4016/4116A/GMA 125/618DM CRT MODULE THREADS OBSTRUCTED

4052/4052A/4054/4054A AND 4050E01 RESTART CIRCUIT MOD

Corporate Mod #M48904.

Schematic Changes

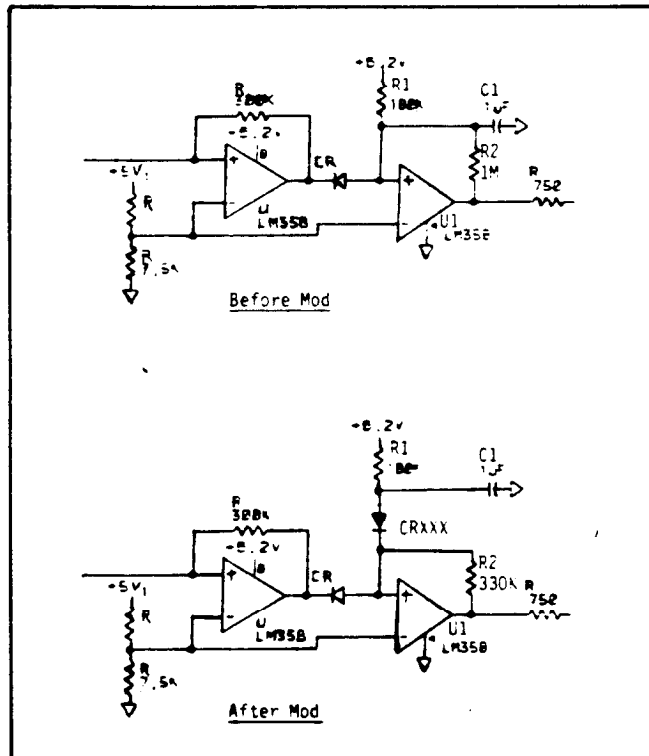
Identical power up restart circuits on the 4052/4052A power supply, 4054/4054A I/O boards and the 4050E01 power supply have a design defect which can cause the restart signal to pulse several

times. This can cause the system to hang or for the 4050E01 to power up in the opposite mode than the product to which it is connected. The malfunction can also show up on the 4050E01 as intermittently changing modes.

Corporate Mod #M48904 fixes this restart malfunction with a design change. The change is as follows:

One end of both a 1 uf cap (C1) and a 180K Ω resistor (R1) are connected to the plus input of the OP AMP (U1) in the circuit involved. Lift this end of both components and "teepee" together. Insert and solder in the cathode end of a 1N4152 diode (CRXXX) into the hole from which the end of the "teepeed" resistor (R1) was removed. Connect the other end of the diode to the "teepeed" resistor and capacitor (R1, C1) and solder together. Last, replace the 1M Ω resistor (R2) with a 330K Ω resistor. Below are part numbers for CRXXX and R2.

Diode CRXXX	152-0141-02	1N4152
Resistor R2	315-0334-00	330K

Board Name - Input/Output Board
Board P.N. - 670-7630-01 rolls to -02
Ckt. Involved - U265B (+ input = pin 5)
Lift - R265 and C267
Add - CR265
Change - R266

Board Name - Power Supply Ckt. Bd.
Board P.N. - 670-7210-01 rolls to -02
Ckt. Involved - U205A (+ input = pin 3)
Lift - R202 and C202
Add - CR203
Change - R201

Board Name - Regulator Circuit Board
Assy. P.N. - 620-0278-00 rolls to -02
Bd Assy P.N. - 672-0833-01 rolls to -03
Ckt. Involved - U271A (+ input = pin 3)
Lift - R272 and C271
Add - CR272
Change - R263

Board Name - Input/Output Board
Board P.N. - 670-5666-02 rolls to -03
Ckt. Involved - U270B (+ input = pin 5)
Lift - R260 and C262
Add - CR261
Change - R261
